Access Compliance Report

Public Rights-of-Way

(Curb Ramps)

Intersection ID: 9432	Main Street: BEATTIES_FORD_RD	Cross Street: W_BROOKSHIRE_RA	Location: SW
ADA ID: 68EB61CFC75D	Ramp Type: Perp	Initial Pass/Fail: Fail	Overall Compliance: No
Severity Score: 12.5			
Codes/Mitigation Info/Possible Solution		Field Measurements/Component Compliance

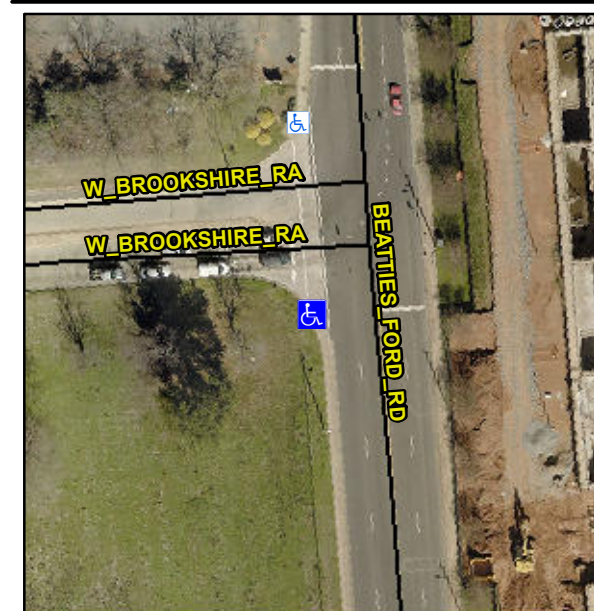
Not Found, R304.2.2

Compliance	Description	Data	Compliance	Description	Data
N/A	Ramp Length (in)	59.5	No	Ramp Slope (%)	8.8
Yes	Ramp Width (in)	76.5	Yes	Ramp XSlope (%)	0.4
N/A	Flare Type LT	N/A	N/A	Flare Type RT	N/A
N/A	Flare Slope LT (%)	N/A	N/A	Flare Slope RT (%)	N/A
N/A	Flare Traversable LT?	N/A	N/A	Flare Traversable RT?	N/A
N/A	Landing Length (in)	N/A	N/A	DWS Provided?	N/A
N/A	Landing Width (in)	N/A	N/A	DWS Contrast?	N/A
N/A	Landing Slope (%)	N/A	N/A	DWS Length (in)	N/A
N/A	Landing X Slope (%)	N/A	N/A	DWS Full Width?	N/A
N/A	Landing Curb? (Y/N)	N/A	N/A	DWS Offset (in)	N/A
N/A	Shared Landing?	N/A			
N/A	Gutter Ponding?	N/A	N/A	Gutter Slope (%)	N/A
N/A	Gutter Lip Ht (in)	N/A	N/A	Gutter X Slope (%)	N/A
N/A	Painted X Walk1?	No	N/A	Painted X Walk2?	N/A
	X Walk 1 Direction	To N		X Walk 2 Direction	N/A
N/A	X Walk 1 Width (in)	N/A	N/A	X Walk 2 Width (in)	N/A
	X Walk 1 Slope (%)	2.7		X Walk 2 Slope (%)	N/A
	X Walk 1 X Slope (%)	2.7		X Walk 2 X Slope (%)	N/A

Remove & Replace Entire Ramp.
